AMENDMENTS TO THE DRAWINGS:

ANNOTATED SHEET SHOWING CHANGES

*Fig 9d*

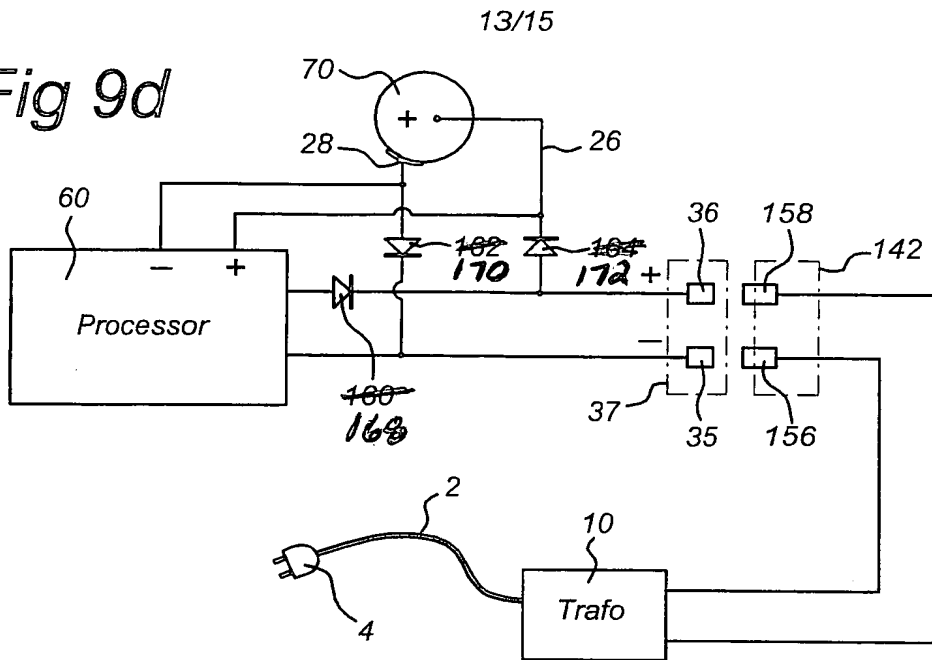
The attached sheet of drawings includes changes to Figure 9d. This sheet, which includes Figures 9d and 9e, replaces the original sheet including Figures 9d and 9e. In Figure 9d, the numbering of the diodes is now the same as in Figure 10 and in conformity with the description. Specifically, elements 160, 162 and 164 have been changed to --168, 170 and 172-- respectively.

Additionally, Figure 9d has been amended as shown by the attached annotated sheet in which the numbering of the diodes has been corrected to conform with the description in the specification.
